9/13/96	Class B Concrete changed to Class A.
6/14/96	Notes added to clarify plans.
DATE	REVISION
STATE OF HAWAII DEPARTMENT OF TRANSPORTATION HIGHWAYS DIVISION	
DRAINAGE PLAN	
KALANIANA'OLE HIGHWAY RESURFACING	
Kailua Rd. to Hilo St.	
Project No. 72A-01-96M	
Scale: 1"=40'	Date: May 1996
SHEET No. 44 OF 44 SHEETS

KALANIANA'OLE HIGHWAY RESURFACING

Project No. 72A-01-96M

FED. ROAD DIST. NO.	STATE	FED. AID PROJ. NO.	FISCAL YEAR	SHEET NO.	TOTAL SHEETS
HAWAII	HAW.	72A-01-96M	1997	C.O. 55S-12	55

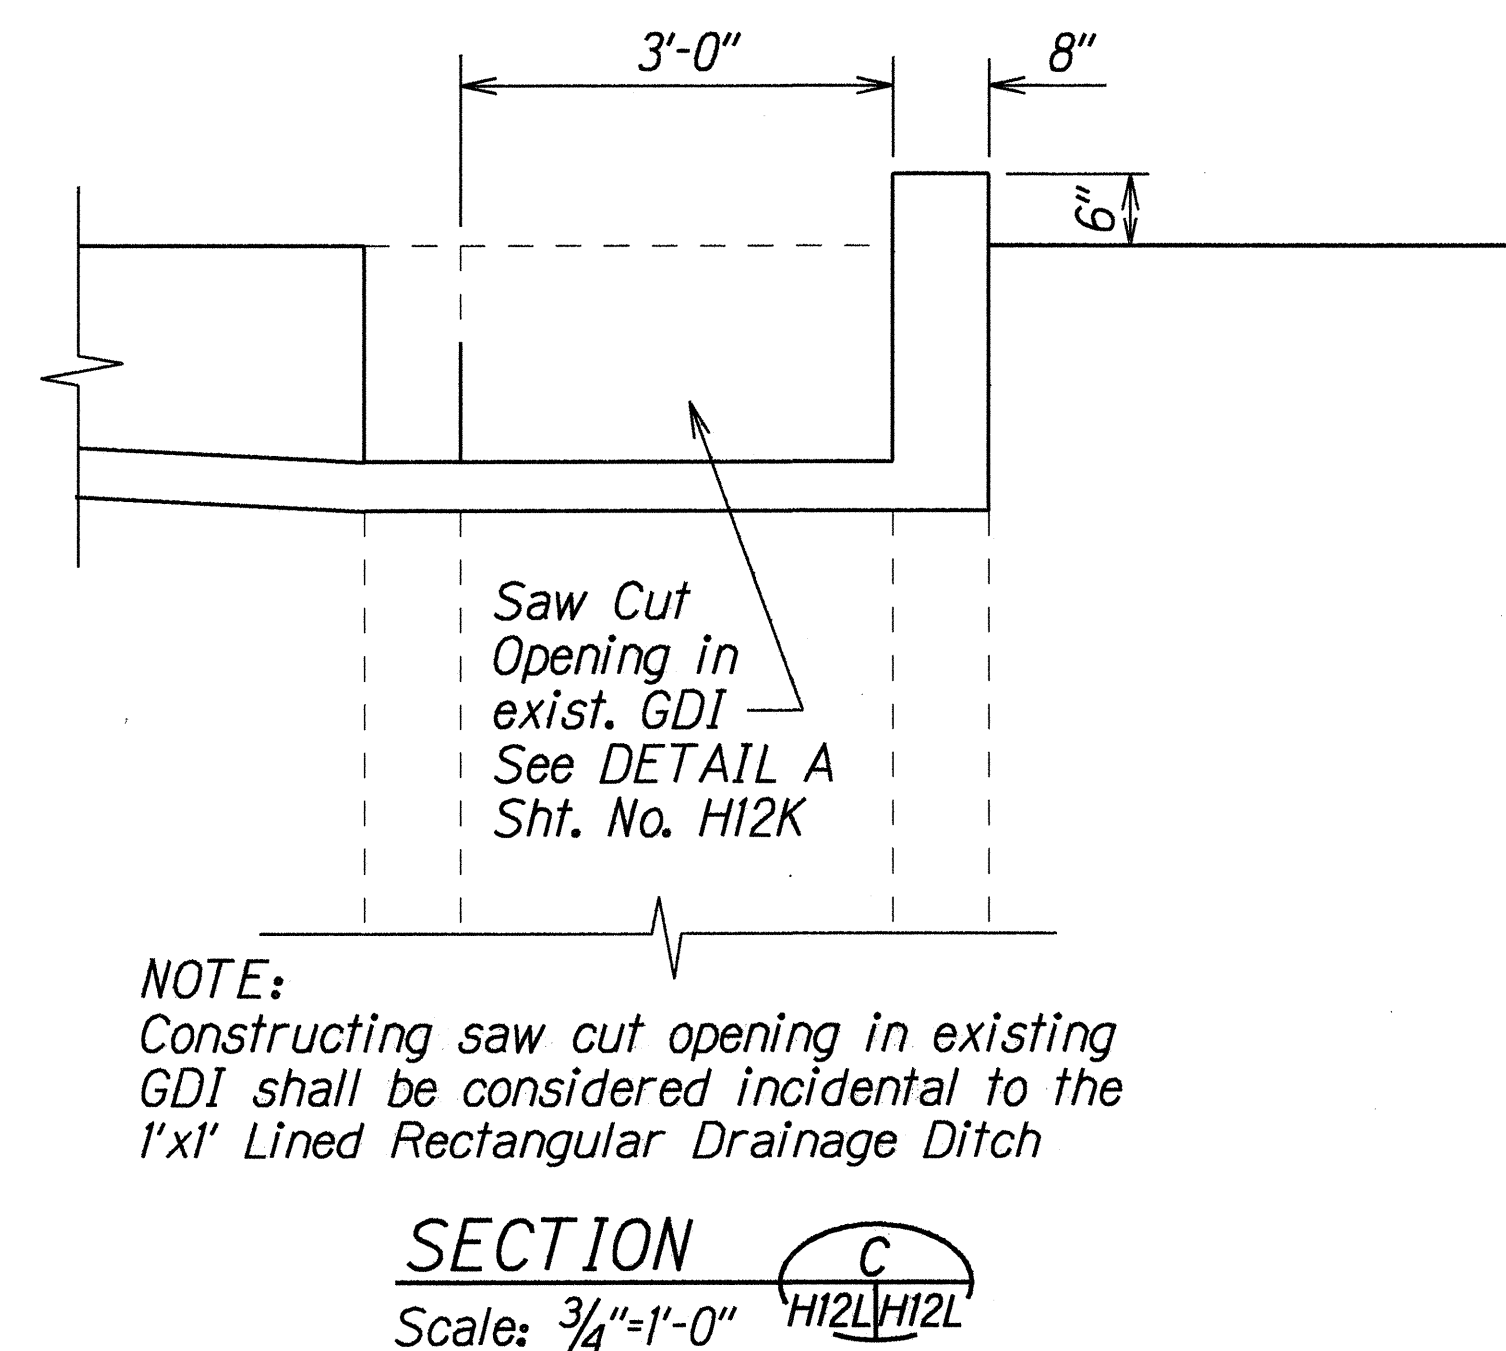
12/5/96	Revised Transition of 1'x1' Lined Rectangular Drainage Ditch.
9/13/96	Sheet added to show details of 1'x1' Lined Rectangular Drainage Ditch Transition at Sta. 57+50± Rt.
DATE	REVISION
STATE OF HAWAII DEPARTMENT OF TRANSPORTATION HIGHWAYS DIVISION	
<u>DRAINAGE DETAILS</u>	
KALANIANA'OLE HIGHWAY RESURFACING	
Kailua Rd. to Hilu St.	
Project No. 72A-01-96M	
Scale: As Shown	Date: Jul. 1996
SHEET No. H12L OF 12 SHEETS	
C.O. 55S-12

NOTE:
Constructing saw cut opening in existing GDI shall be considered incidental to the 1'x1' Lined Rectangular Drainage Ditch
